Addendum Number 2
May 16, 2024

MULTIMEDIA CENTER RENOVATION
W.W. STEWART HALL
Southern University and A&M College
Baton Rouge, Louisiana 70813

ADDENDUM 2

Addendum # 2

SHEET TITLE:
Finish Schedules
SHEET NUMBER
A5.03
M3A ARCHITECTURE, PLLC

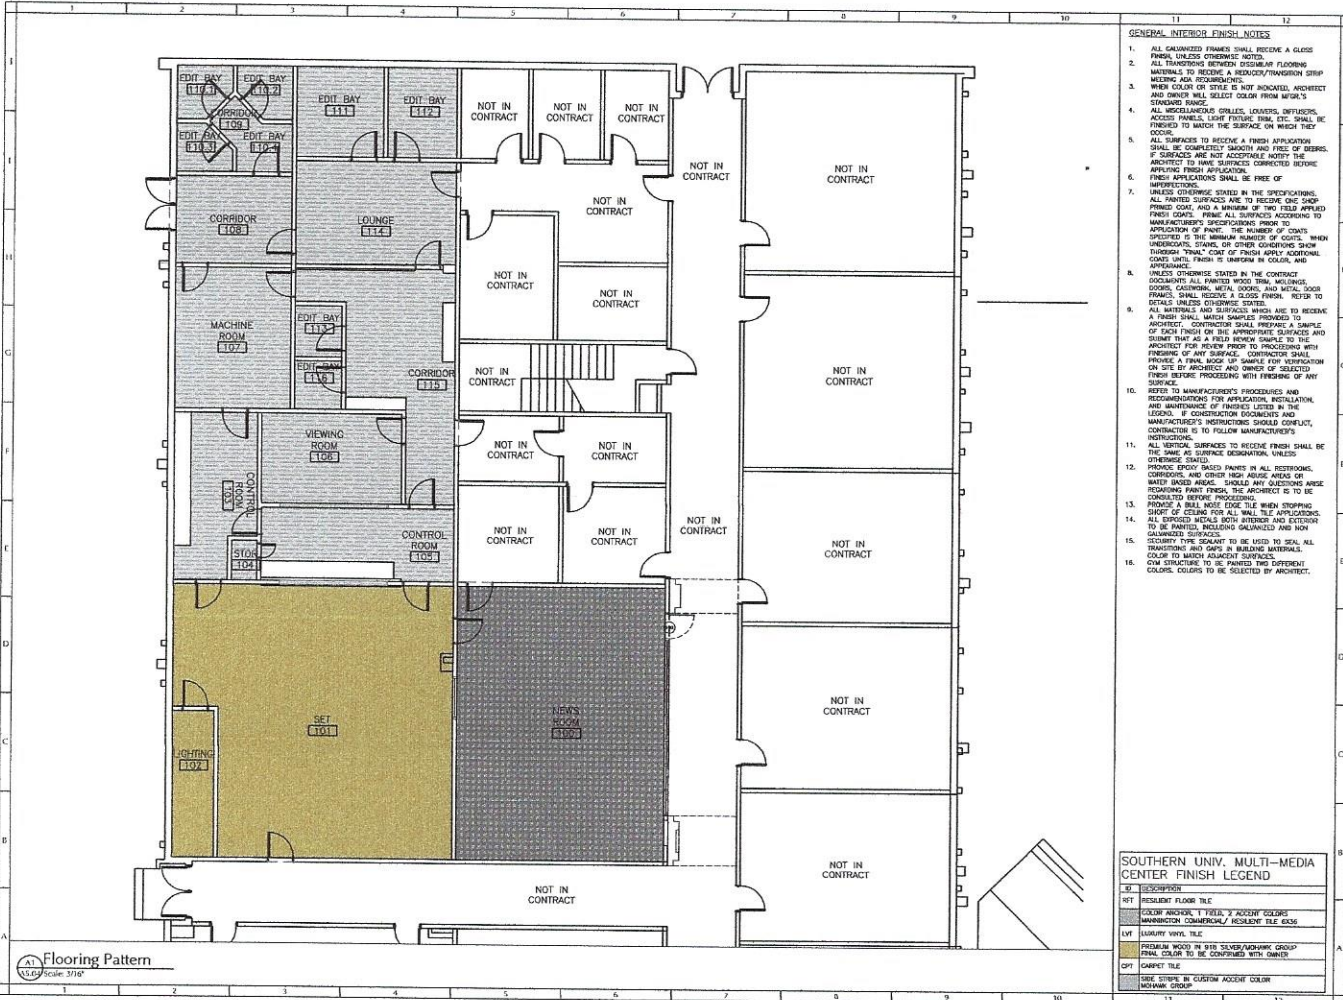
4. Alternate #2 is for ALL finishes in the project rooms except for the news room and corridor. The finish schedule says all paint finish is in the base bid? What finishes are in the base bid and what finishes are in Alternate #2. If flooring is part of this alternate, then is the demolition also in the alternate or base bid?

1. The finish schedule sheet has been revised and updated. Alternate 2 is for all finishes in the project rooms, except the news room and corridor (which is included in base bid). Where project areas are to receive new LVT flooring, there will be no demolition; instead new flooring will overlay existing. At room(s) to receive new carpet, existing flooring is to be

demolished. Associated demolition is included in respective phases of work, ie base bid or alternates.

SHEET NUMBER:
E1.03
M3A ARCHITECTURE, PLLC

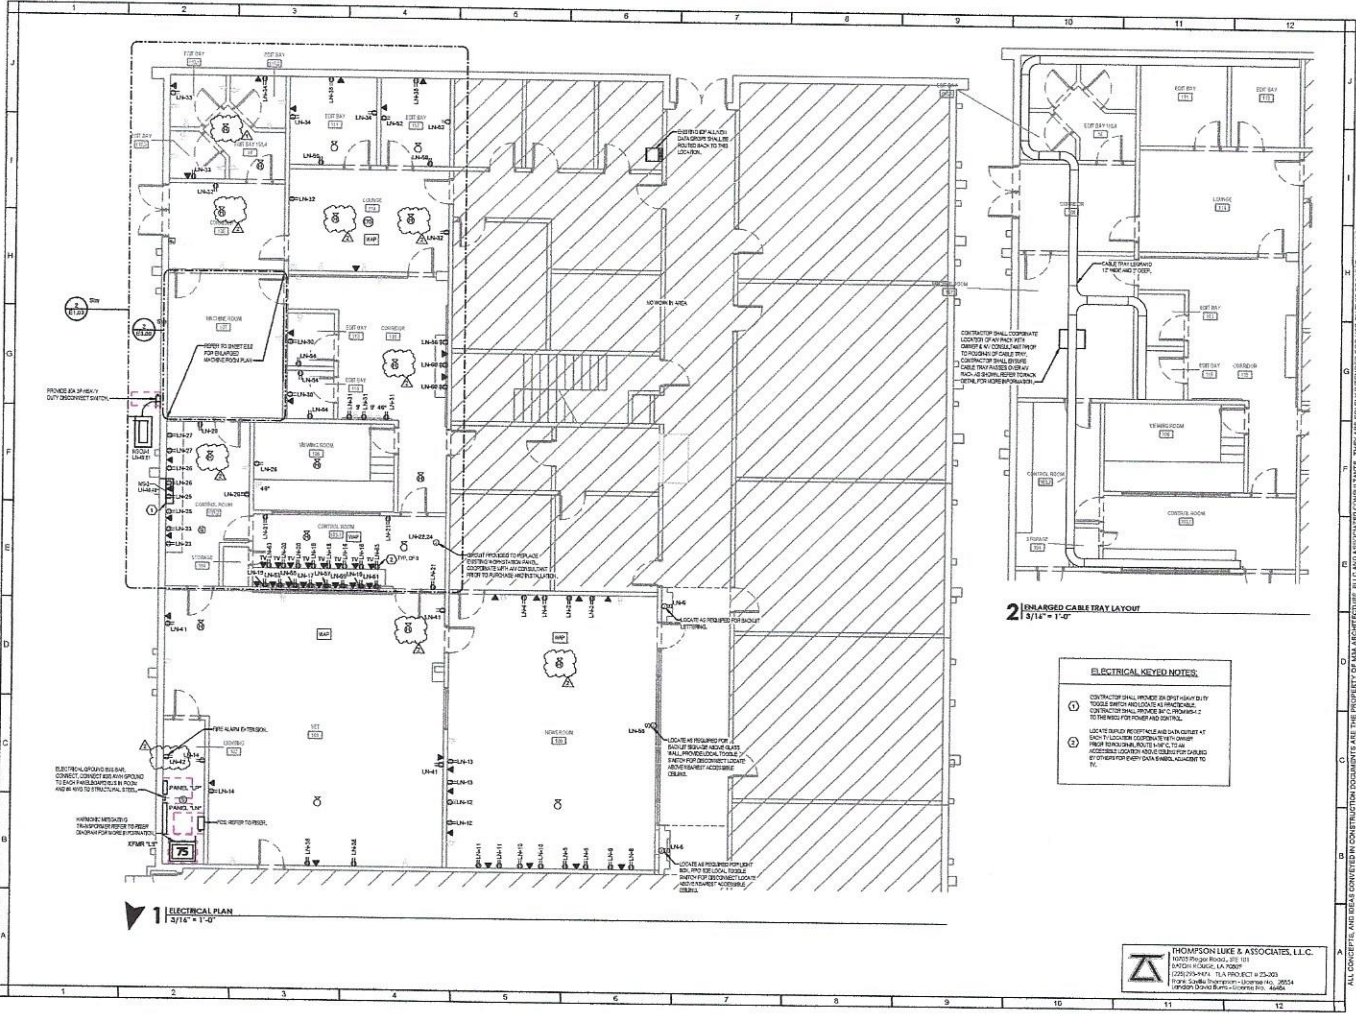
- a. **Simplex devices are permitted for use. Refer to Spec section below for more information.**
2. Q. The symbol legend on sheet E0.00 indicates that the fire alarm notification devices are either speaker/strobes or strobe only devices.. The devices as shown on the project area as shown on sheet E1.03 indicate to provide speaker/strobes. Please note that the notification appliances on floors 1 through 3 are either combination HORN STROBES or strobe units. Only the Auditorium (assembly) portion of floor uses fire alarm speakers. We request that the new notification devices to be installed in the project area be changed to HORN/STROBES in lieu of speaker/strobes to prevent confusion during a fire alarm. This will prevent mixed notification types. Additionally,, the building is a "B-Business" occupancy which does not require voice evacuation per our interpretation.

- b. **Speaker Strobes are permitted to be replaced with HORN/STROBES. Refer to plan changes for more information.**
3. Q. T As the project will require the addition of a signal extender panel to power the new notification devices added in this project. We request what

location in the project area would be most suitable for the additional of the new extender. The new panel will require a dedicated 120VAC 20-amp circuit. The dimensions of the enclosure are 16.25" W x 13.5" H x 4.25" D.

c. **New dedicated receptacle located in electrical room. Refer to plan change for more information.**

1. Refer to SHEET E1.03 – ELECTRICAL POWER PLAN for the following changes:
 - a. Added receptacle for Fire Alarm Extension.
 - b. Changed Speaker/Strobes to Horns/Strobes.
2. Refer to SHEET E3.00 – ENLARGED PLAN, SCHEDULE, & EXST. RISER for the following changes:
 - a. Changed Speaker/Strobes to Horns/Strobes.
3. Refer to SHEET E4.00 – ENLECTRICAL SCHEDULES for the following changes:
 - a. Updated panel schedule.
